Project #A1322-01 Edna Mahan / Hunterdon Developmental Solar PPA

Bulletin D

PROJECT#: A1322-01 Edna Mahan / Hunterdon Developmental Solar PPA

A/E: Mott MacDonald

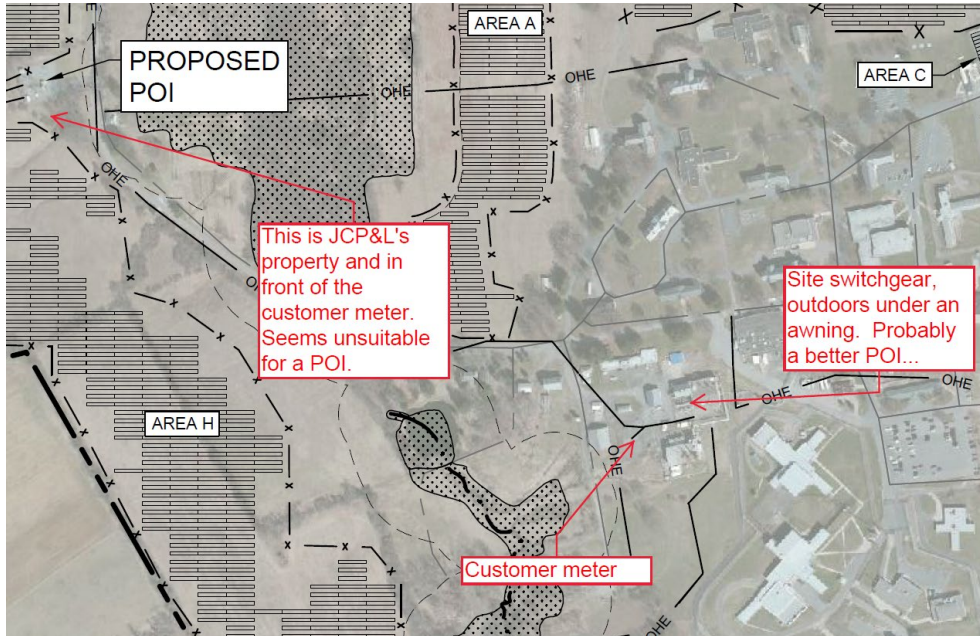
1. I was hoping you could provide info on evaluation criteria for the bid. As all vendors have been pre-qualified are we to assume that the decision will be based 100% on price or are other factors to be considered as well?

Answer: The T3104 Exhibit 2 – Bid Evaluation Tool will be used first to find the best value group from all the bidders. This process filters the vendors in order with a combination of the best rate and size of the system being proposed. Following that analysis, the 3 best value vendors will be notified by the State to send digital copies of their plan and an interview will be scheduled with all 3 vendors on the same day. During the interview process the Vendor, State representatives and the project consultant will complete the T3104 Exhibit 5 - Post Bid Interview Certification specific for the project, which includes questions regarding feasibility of the plan, schedule, approach to interconnection agreement, energy yield, design, decommissioning security approach and warranty.

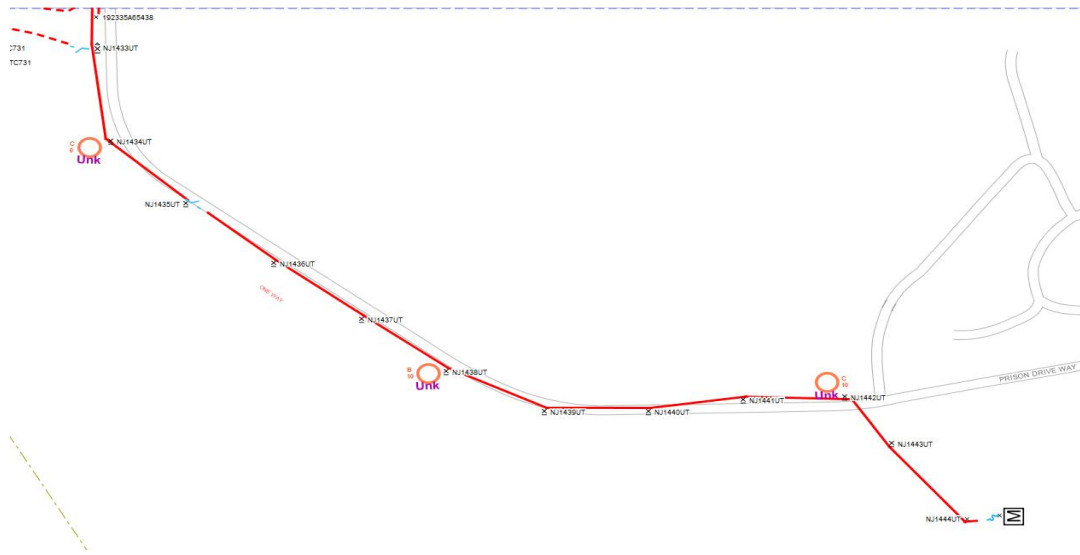
3. Can you provide the location of the highest consuming electric meters and the location and ownership of the electrical equipment on the utility and customer sides of these meters? Based on the electricity data provided, the highest consuming electric meters look to be JCPL Meter # L014003810 and Champion Energy Service Meter # 08004766210000644162-ESP, which are showing an average monthly electricity use of 1,260,586 kWh and 1,149,000 kWh, respectively. Is this accurate?

Answer: JCP&L has provided a usage report from Sept 2018 through August 2020. (*See Attachment A1 of this Bulletin*). Note that we started the purchase from the 3rd party supplier Champion in April 2019. The 3rd party supplier typically uses the utility meter for billing and does not have their own meter. On the attachment A1, you will see the overall electric consumption column in kWh for the site, measured at the L014003810 meter. It is Not accurate to add the 3rd party and utility usage together.
